Historical Architectural Review Board
COA Preliminary Review Sheet

HDC-2025-00008

Address: 1528 Linden Street

Proposal: Violation correction - Vertical platform lift installation with landing infill and railings.

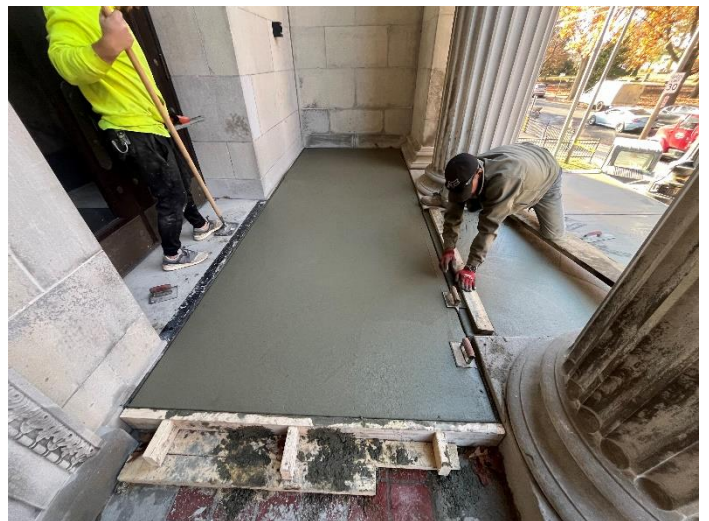
The completed work to date includes a new at-grade sidewalk, a formed concrete landing over the top of existing stairs, metal railings at this new landing, and concrete fill over existing tiles at the existing entry door.

The Guidelines recommend considering provisions for reversibility so that modifications can be easily removed without damaging historic fabric in the future. It appears in the photos that concrete was built up over the existing stairs and tiled entryway. Any future removal of this concrete may compromise the integrity of the historic materials.

The new railings at the top landing are similar to the existing stair railings in materiality and finish but appear to have a different profile.
